TECHNICAL REPORT HL-82-2

LAKE PONTCHARTRAIN AND VICINITY HURRICANE PROTECTION PLAN

NUMERICAL MODEL INVESTIGATION OF PLAN IMPACT ON THE TIDAL PRISM OF LAKE PONTCHARTRAIN

APPENDIX B: CONSULTANTS' REVIEWS

Figure 8. Embedded storm surge grid of the three-lake system depicting the tidal prism subgrid

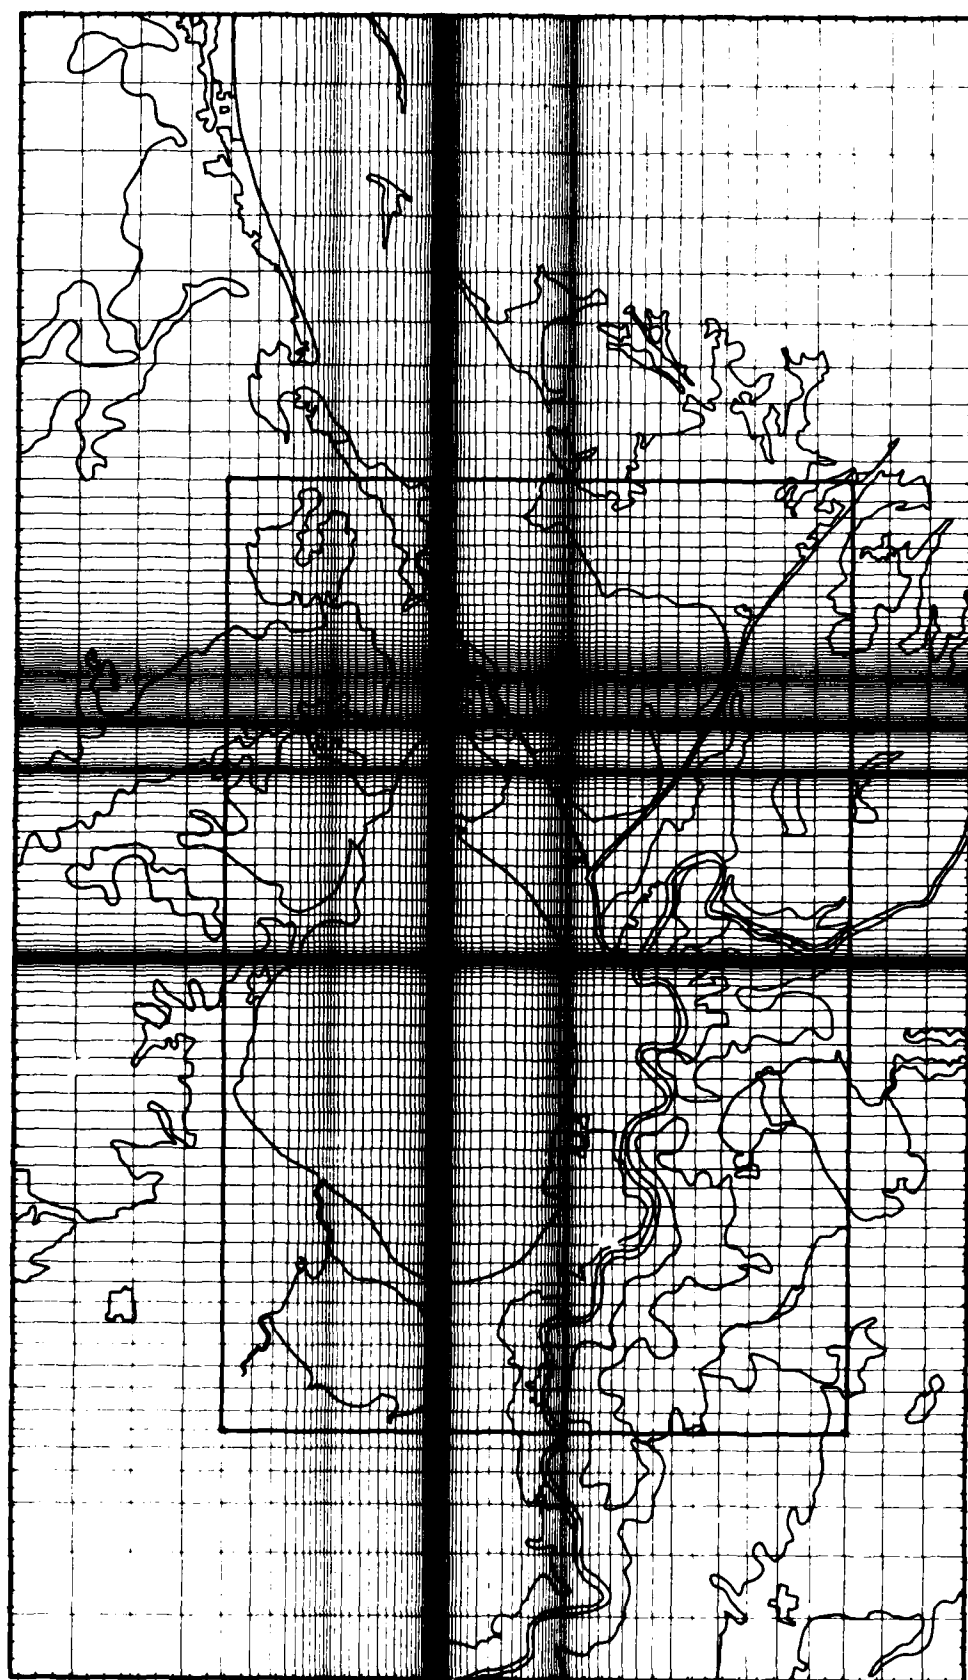
6. Finally, for whatever value you may find them, there follows a couple of editorial suggestions. First, in paragraph 8, I suggest that the following sentence be added to sub-paragraph a: "An embedded subgrid of this model is here after referred to as the tidal prism model". Secondly, in paragraph 40, the last sentence, some explanation as to why velocity vectors which exceeded 0.5 ft/sec were set to zero would aid the reader. Also, in paragraph 31, the 8th line, I believe the reference to Figure 5 should be to Figure 8.

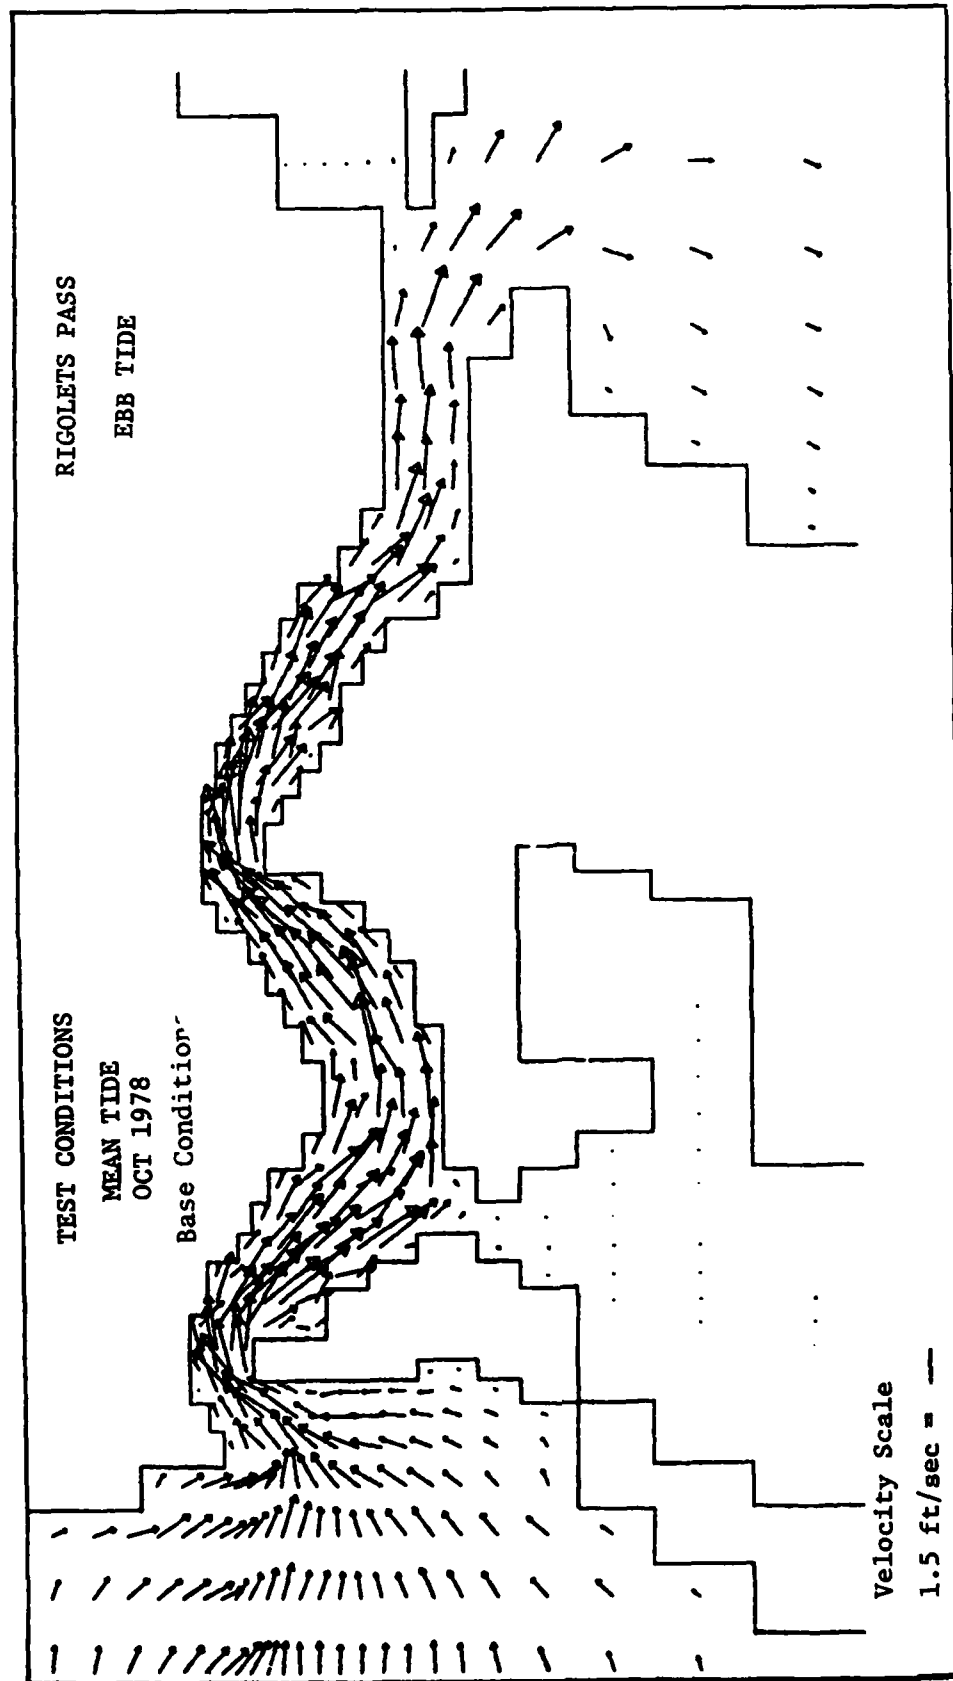
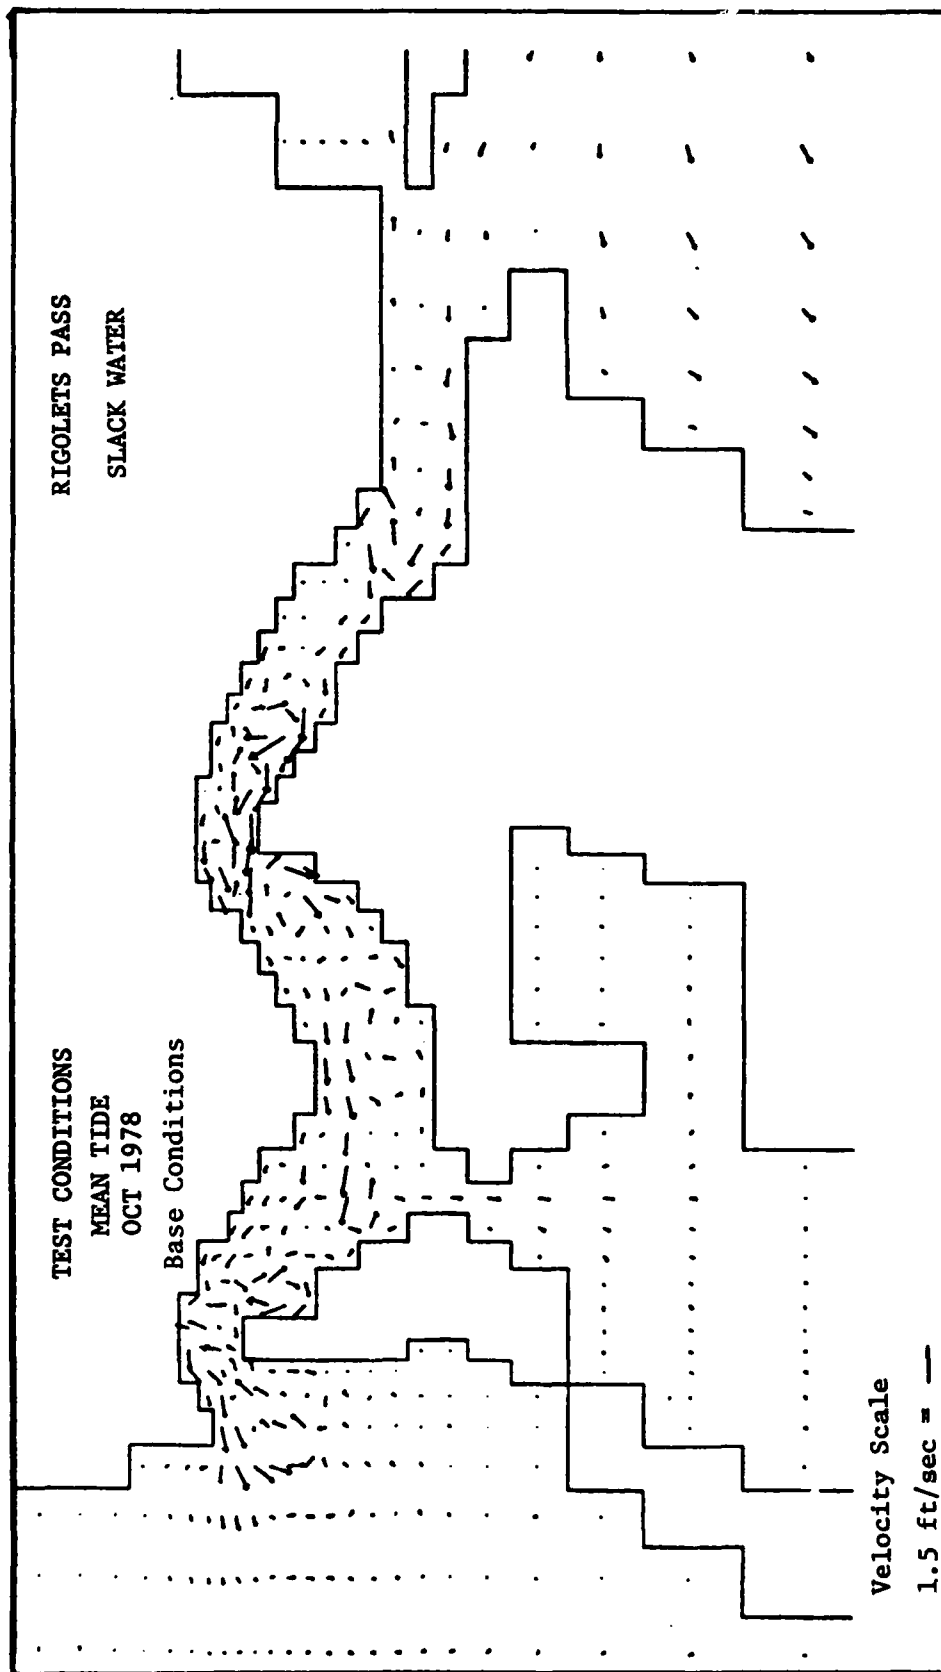
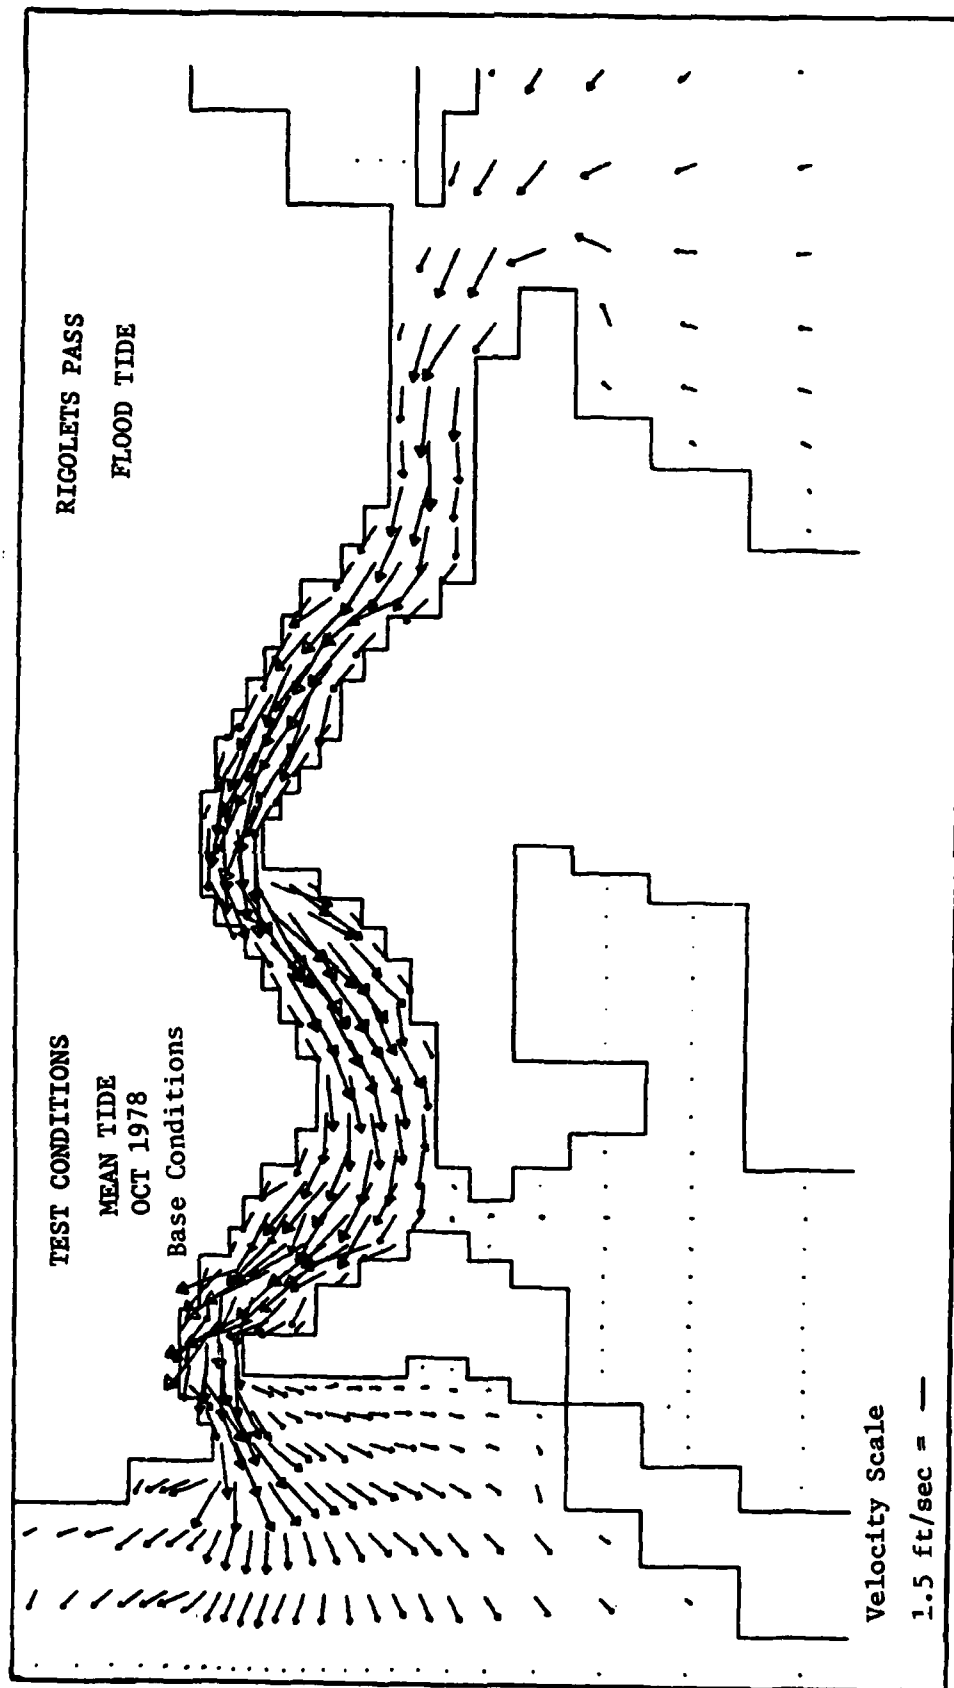
6. Paragraph 41. Plates 17, 19, 21, etc. depict the Chef Menteur Pass as a small, straight and simple tube between Lake Pontchartrain and Lake Borgne. Previous estimates indicate that it has about the same average cross section as The Rigolets, 45% of the minimum cross section of The Rigolets, and transports about 70% as much waters as The Rigolets. Table 4 indicates that the Chef discharges about 60% as much water as The Rigolets during spillway operation. Is the modeled size correct?
